ALASKAN WAY VIADUCT

EVALUATION OF GRAY'S RETROFIT PROPOSAL

Prepared for the
Washington State Department of Transportation

By
T.Y. Lin International

Figure 16 Column curvature versus axial force, retrofitted structure, rare earthquake, middle bents

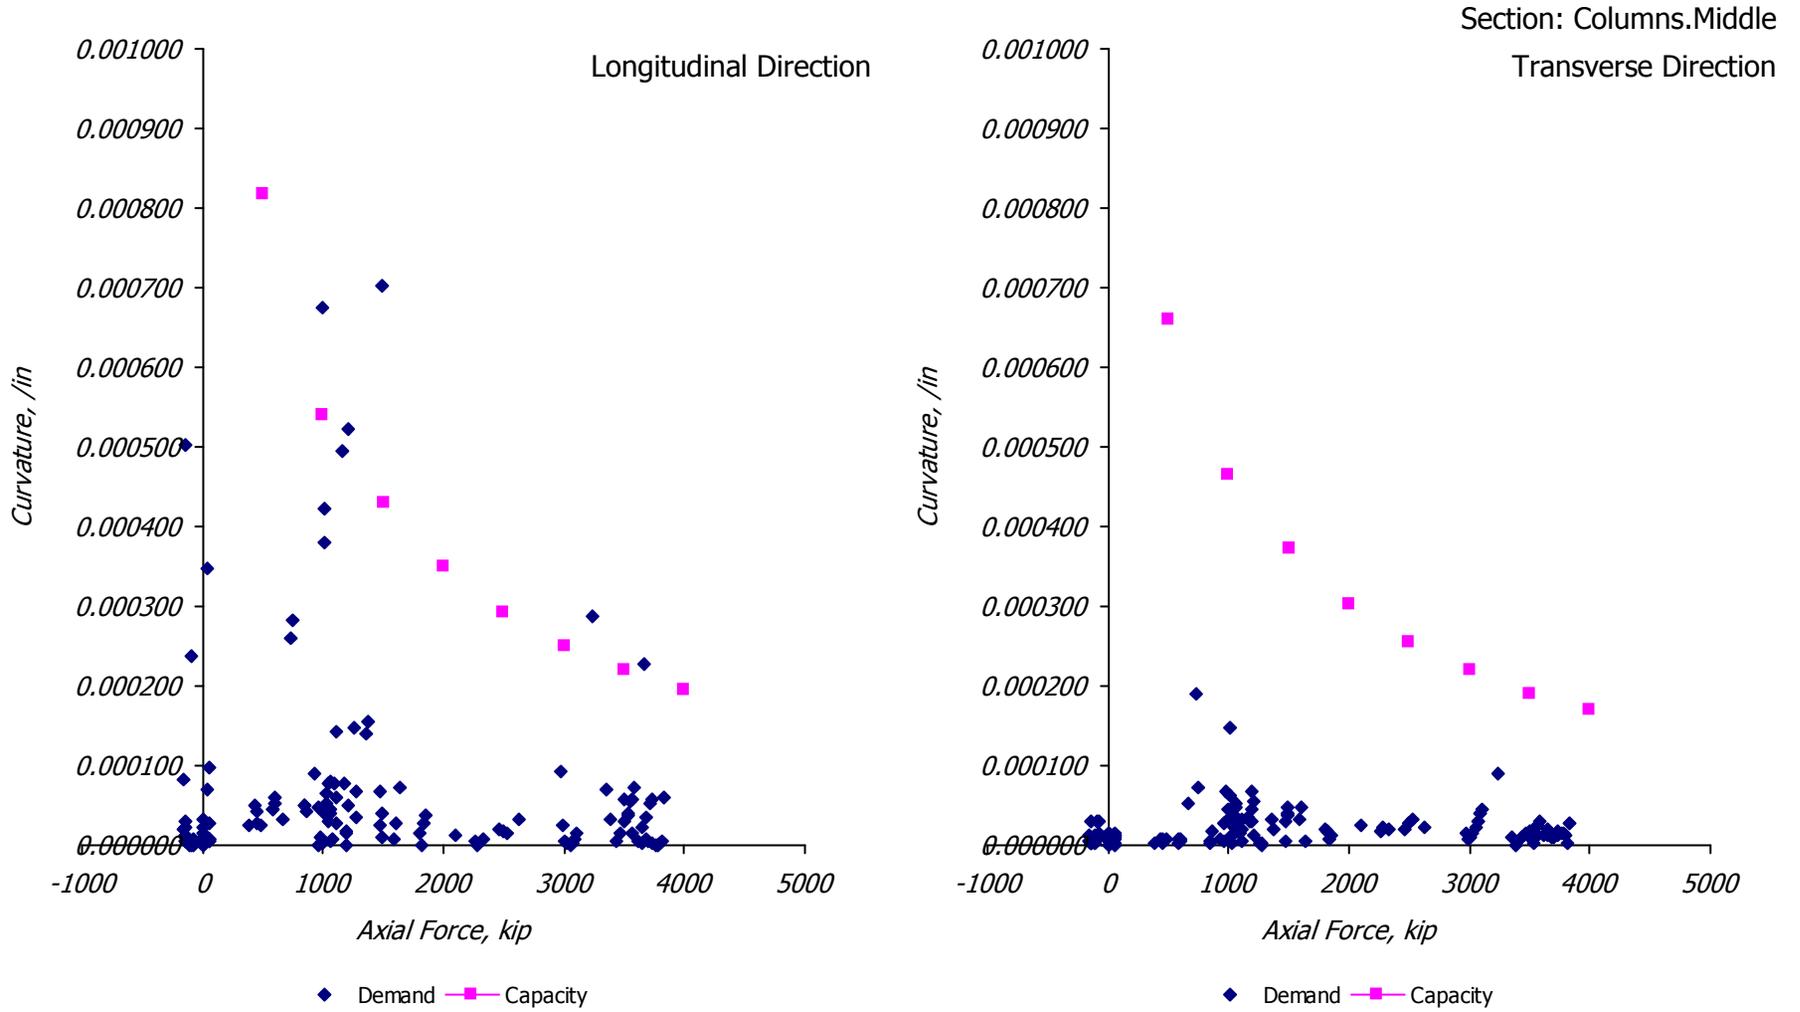
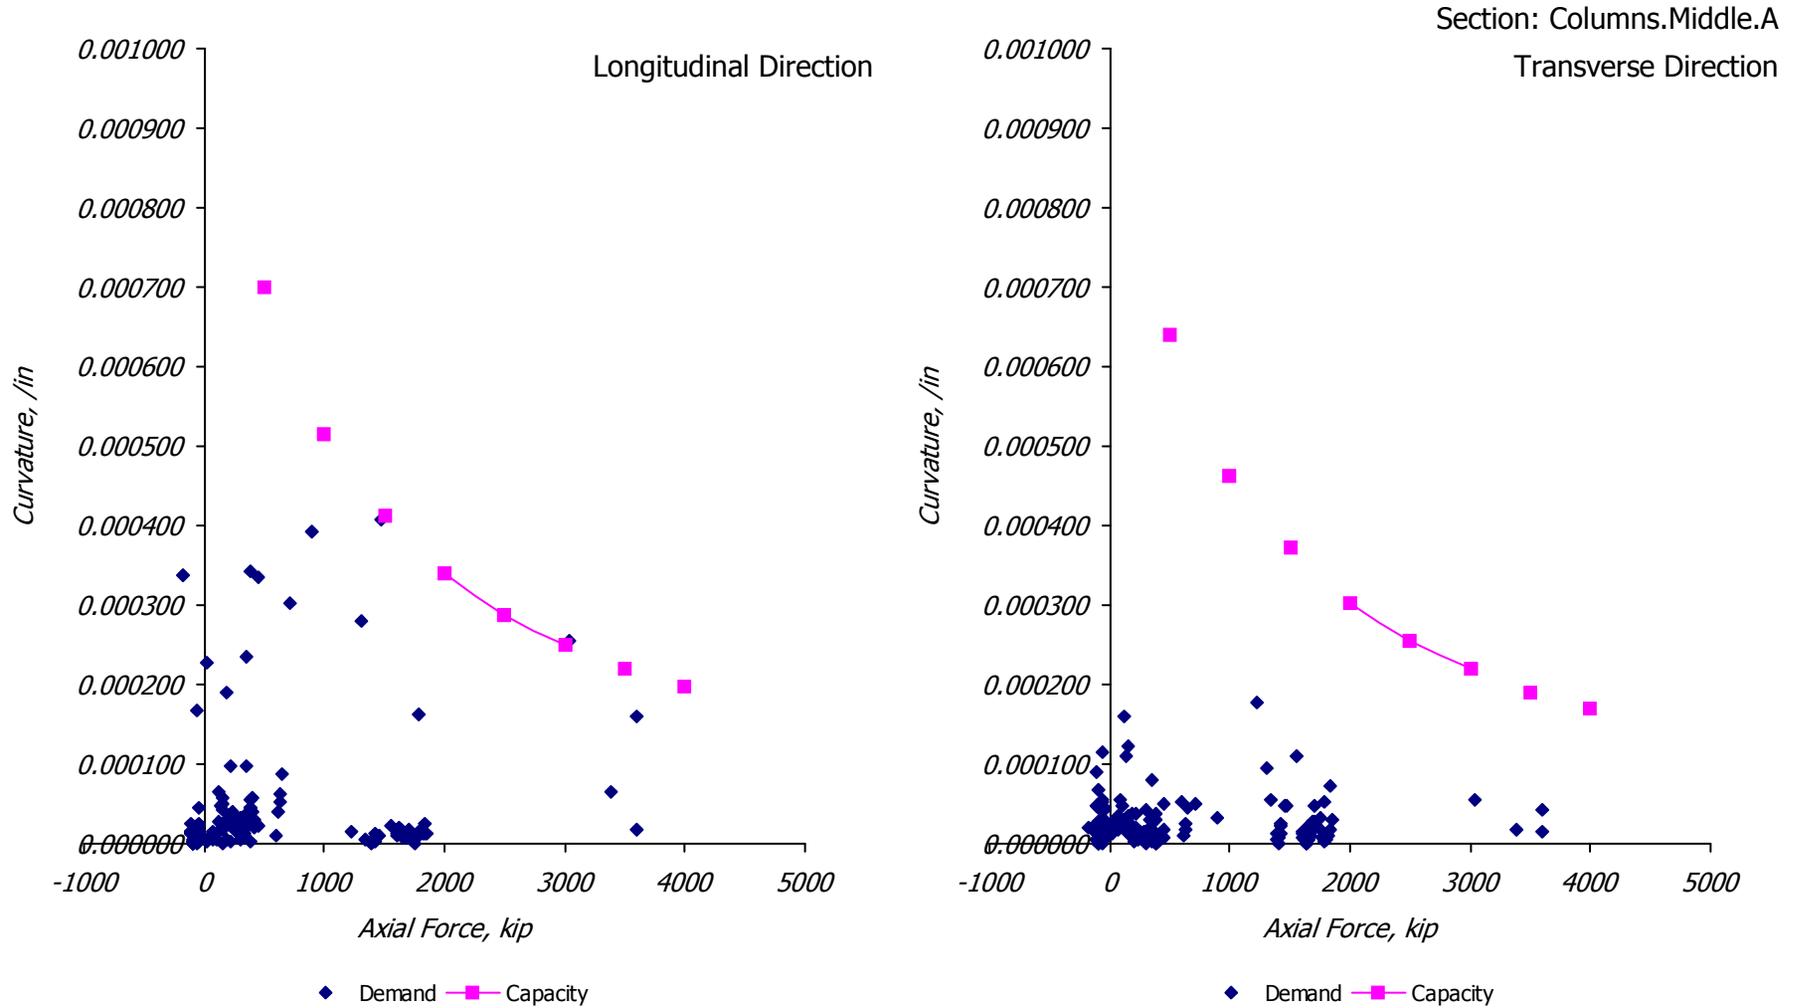
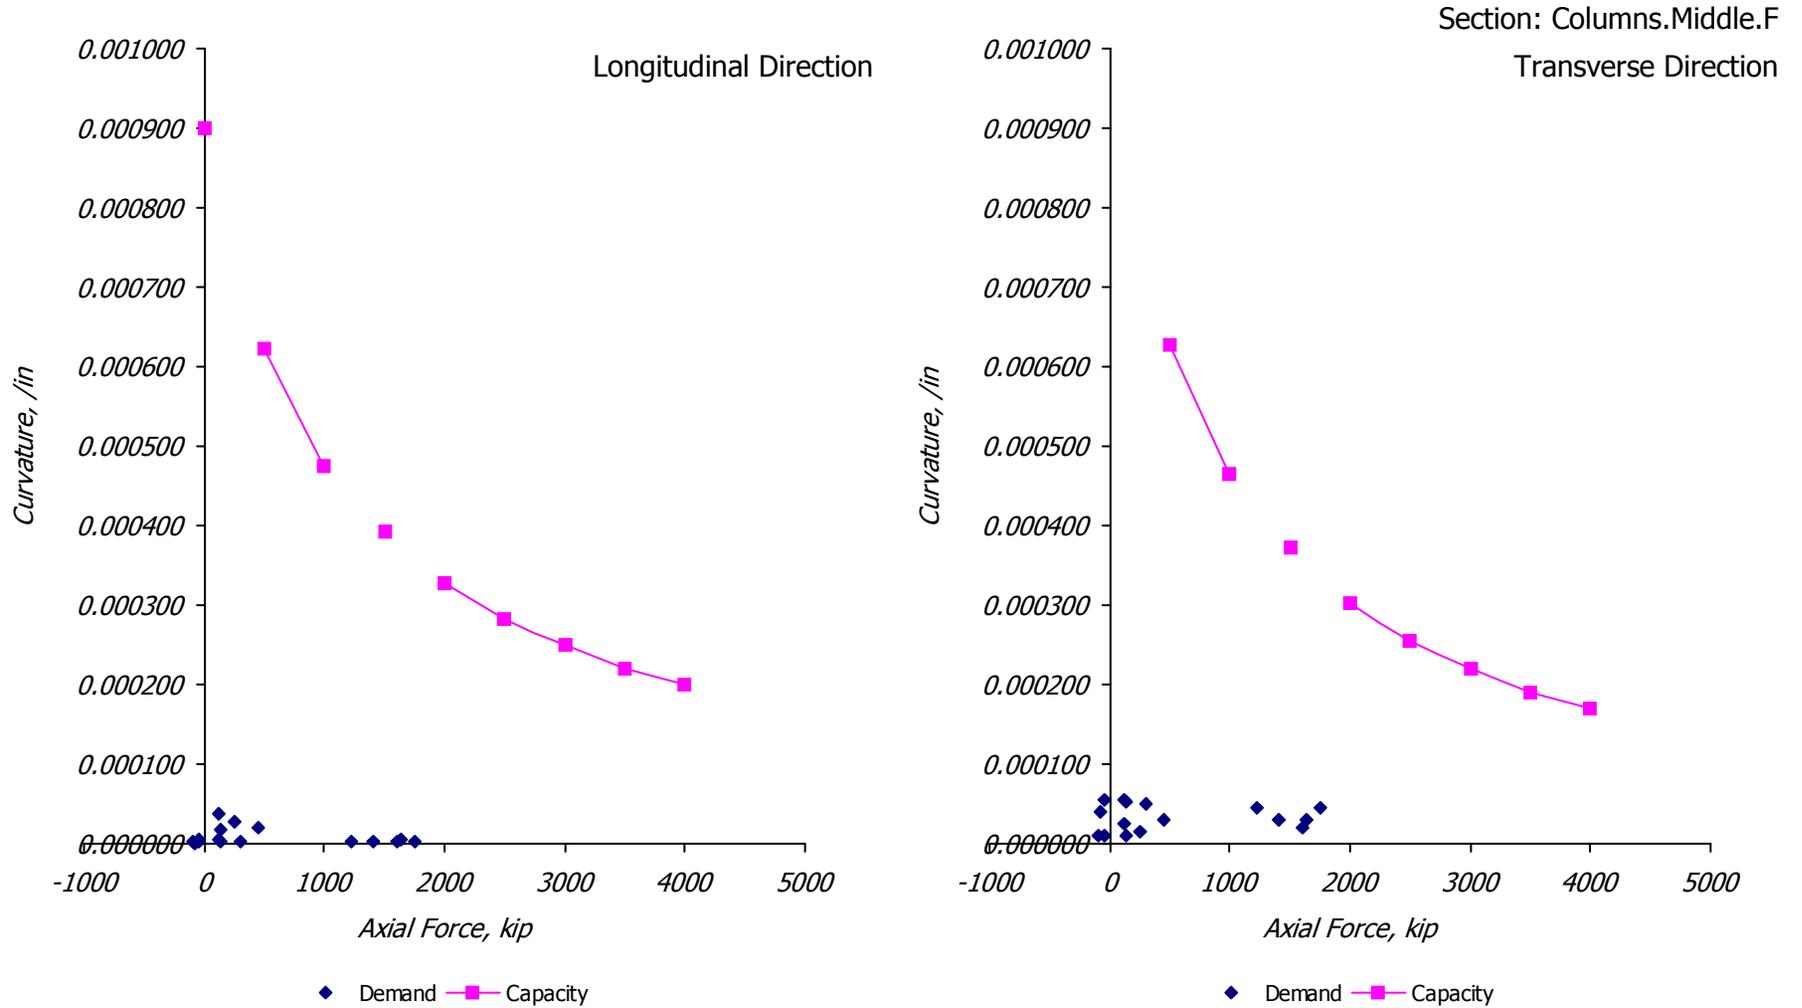
Figure 15 shows that the flexural demands on the end columns slightly exceed the capacity in the transverse direction, for the section designated "Columns.End" (the typical section). Figure 16 shows that the flexural demands on the middle columns slightly exceed the capacity in the longitudinal direction, for the section designated "Columns.Middle" (the typical section). A closer look reveals a more insidious problem, however. The axial forces on the middle columns are very high, over 3500 kip, which is equivalent to a stress of about $0.4 f'_c$. These forces are caused by rocking of the structure and impact of the columns and footings against the piles.

sults are shown in Figure 16. The Mathcad analysis also shows that the column response at high axial load levels is brittle. Catastrophic column—and viaduct—failure would ensue if the curvature capacity was even slightly exceeded. The results shown in Figure 16 indicate that the structure would collapse in a rare earthquake due to combined flexure and axial forces caused by rocking and impact.

Figure 17a

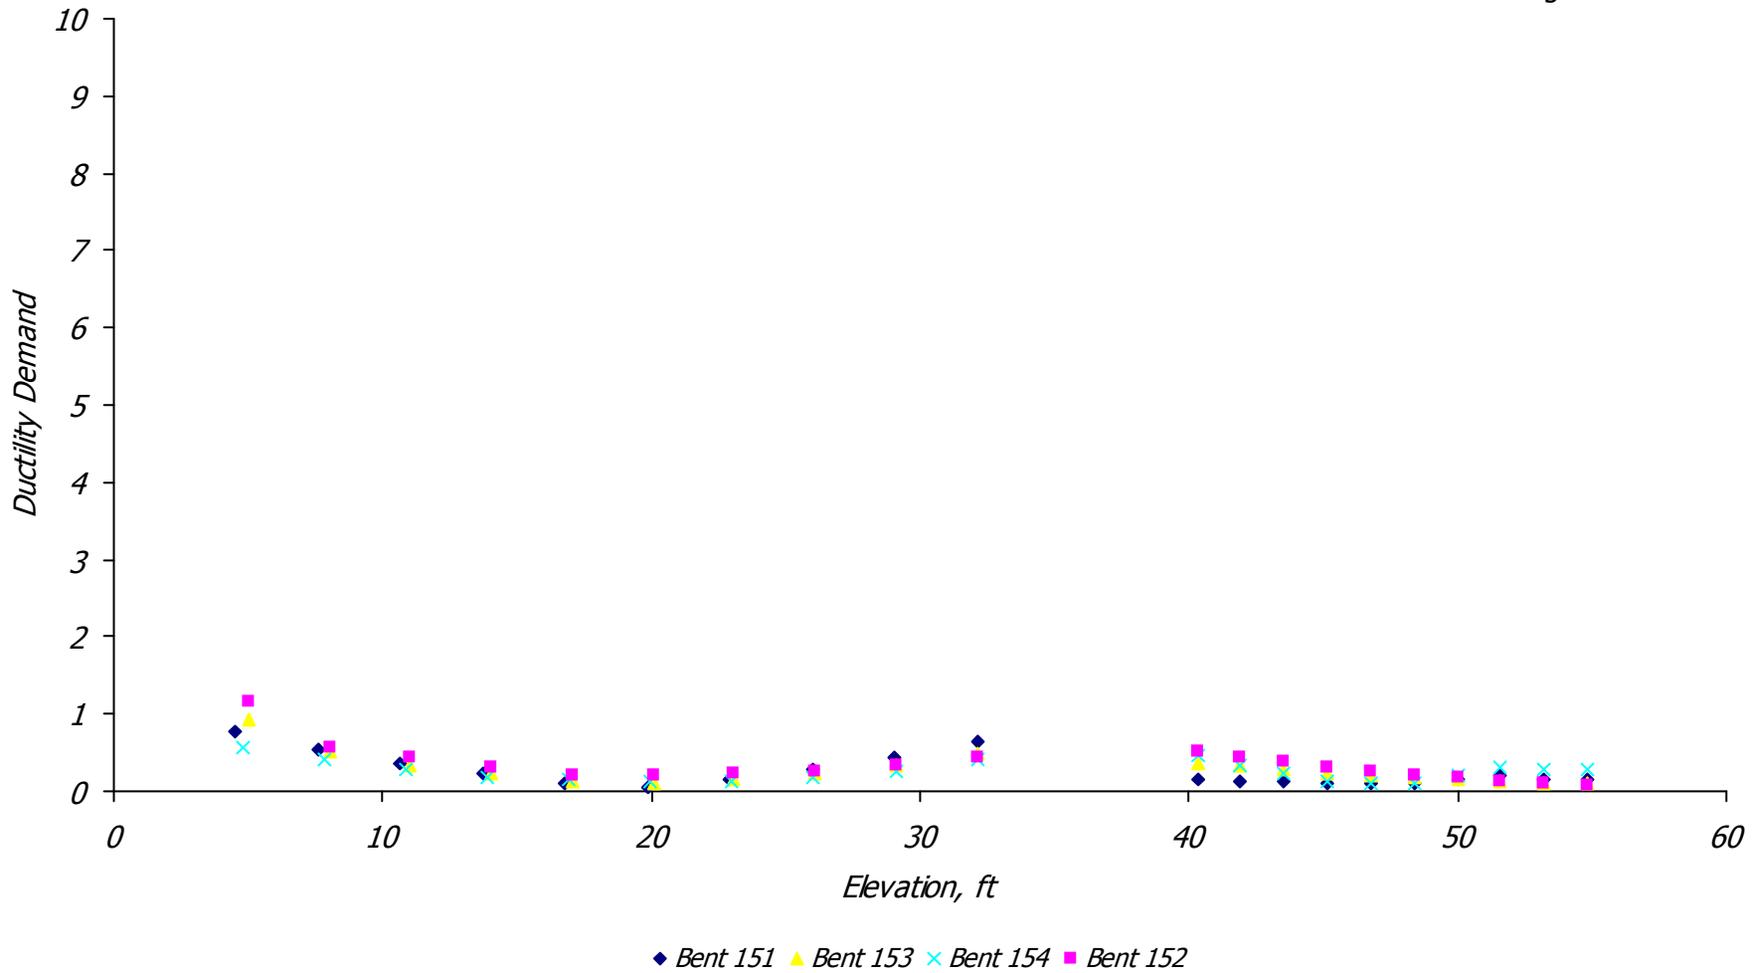
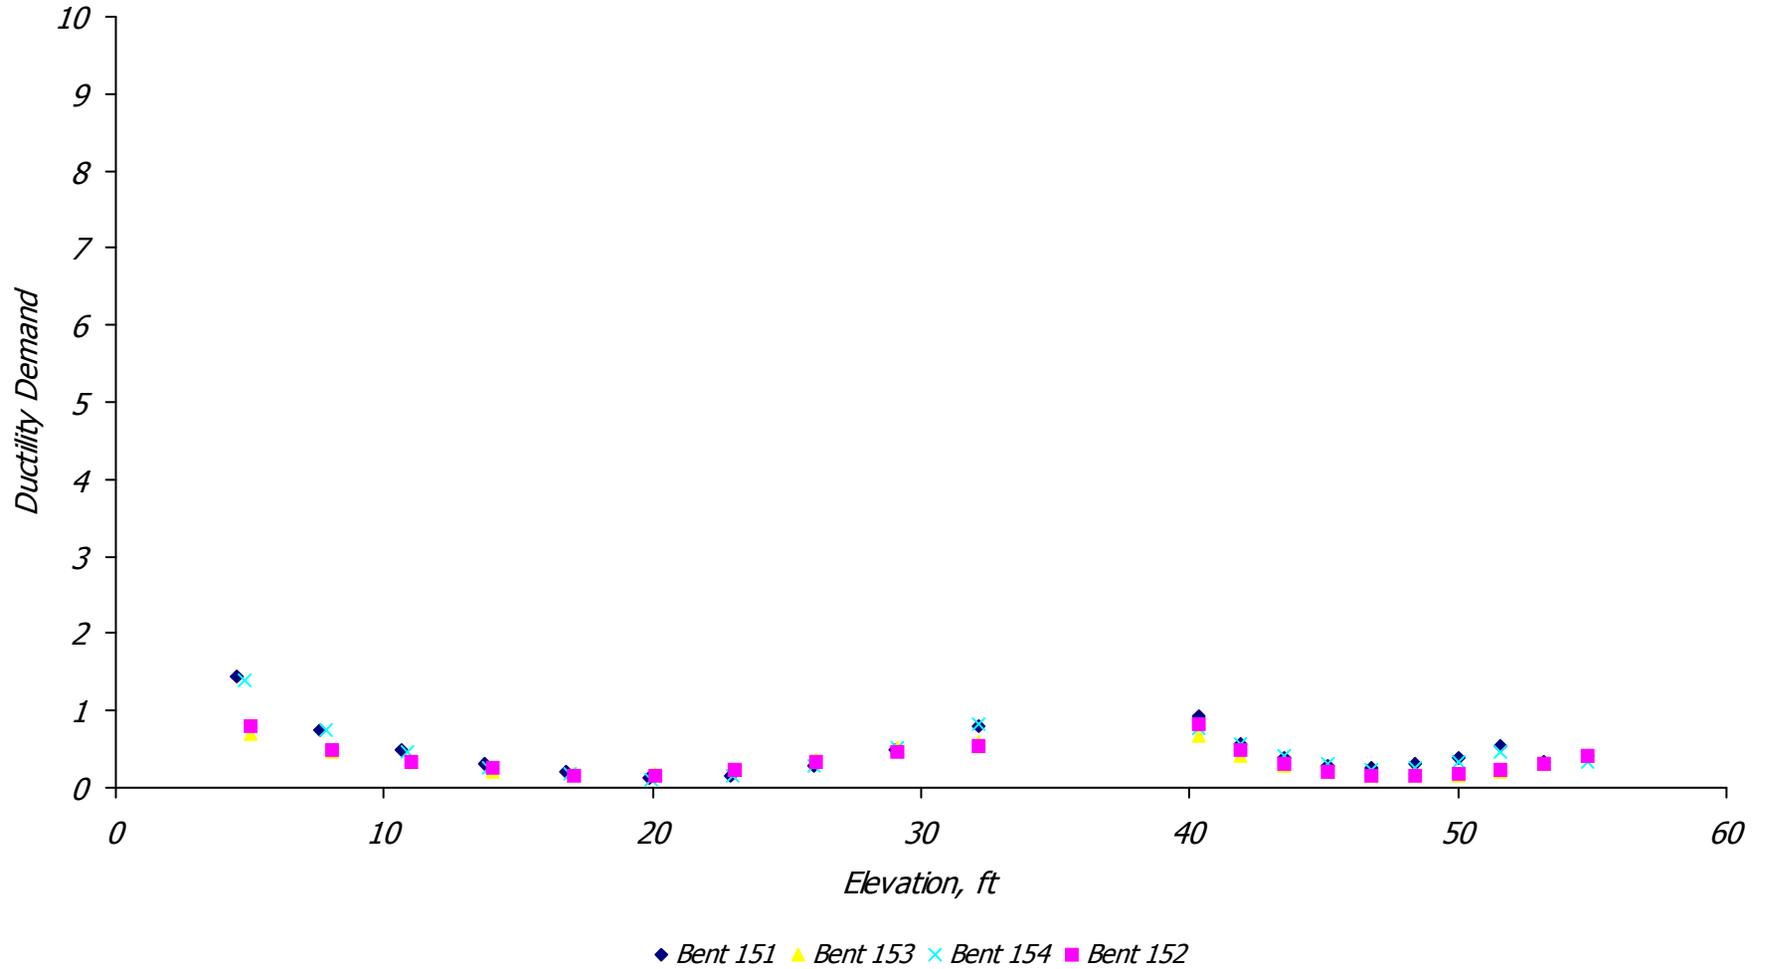
For the design earthquake, the curvature ductility demands on the columns are summarized in Figure 17. The largest values only slightly exceed unity, so damage should be repairable.
